QUESTION ON BID DOCUMENTS (QBD) FORM

Project: AMADOR STREET INFRASTRUCTURE IMPROVEMENTS

Contract No. 2852

PUMP STATION FLOOR PLAN

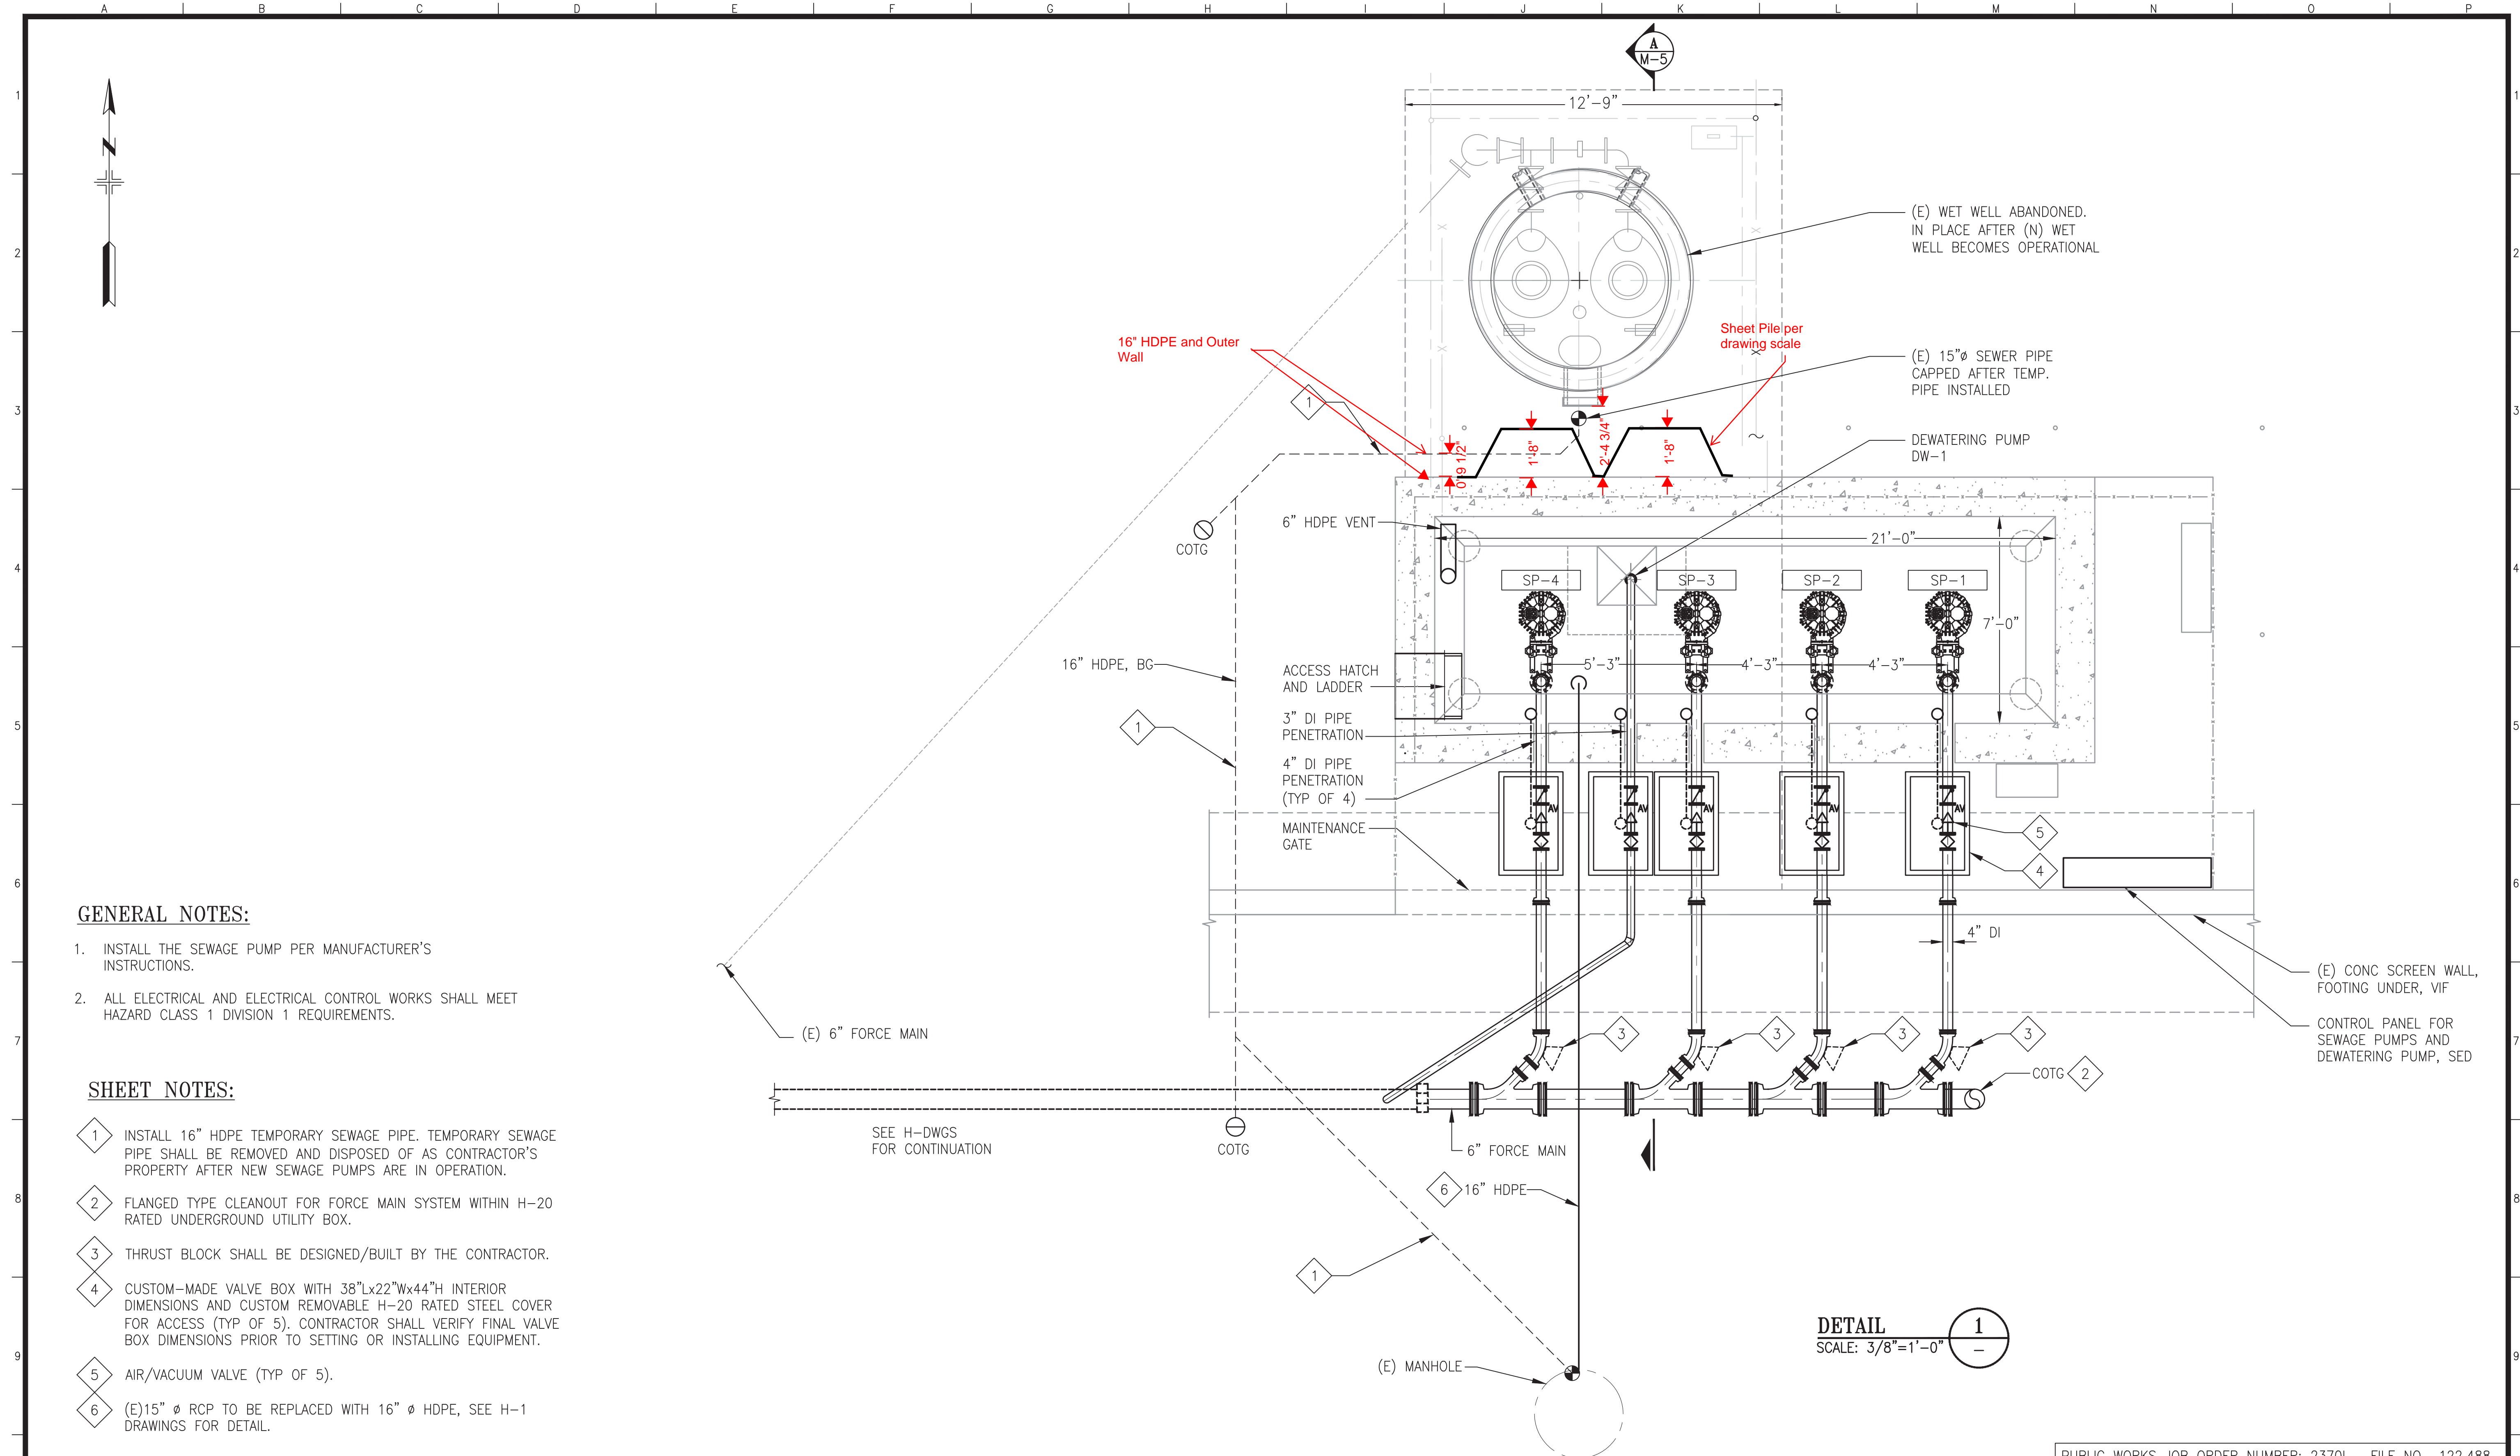
BIDDER'S QUESTION			
Company Name:	<u>ANVIL BUILDERS INC.</u>	Date	<u>8/7/2024</u>
Contact Name:	<u>RICHARD ECKELS</u>	Tel:	<u>415.481.1038</u>
Title:	<u>SUPERINTENDENT/ESTIMATOR</u>	Fax:	<u>415.285.5005</u>
<i>Check One Only (Use separate form for each specification and drawing question.)</i>			
<input type="checkbox"/>	Spec. Section: _____	Paragraph(s):	_____
<input checked="" type="checkbox"/>	Drawing Sheet: <u>M-4</u>	Detail(s):	_____
<p><i>Question:</i> The existing lift station is only 2'4" from the outer wall of the new lift station. The new 16" HDPE bypass per drawings is only 9 1/2 inches from the new lift station outer wall which does not allow for any room to install the permanent sheet piles. As per the detail giving for the PZC26 rolled steel sheet pile the height is 17.7 inches, plus there will be no room to form up the new lift stations outer wall. This is a conflict to install the 16 inch bypass, shoring system and new lift station. Please advise</p>

CITY'S REPLY		
<input checked="" type="checkbox"/>	Mark this box if the QBD can be answered by Bidder's review of the documents. Reply with location(s) where the information can be obtained.	
<p><i>Reply:</i> Attached is the product manual for your reference. The flange height can be from minimum 3.54" to 19.77". please check to see smaller height will work.</p> <p>Refer to M-2 and M-4 Addendum #1 drawings. Existing 15" RCP inlet to be removed providing approximately 3' (to be field verified) between existing lift station and outer wall of new lift station . New 16" HDPE temporary bypass line to be routed as close as possible to existing lift station with final elbow through existing penetration. Contractor to coordinate pipe route with selected sheet pile flange height and existing conditions.</p>		
By:	FP/JC	Bureau/Firm: DPW
Date:	8/9/24
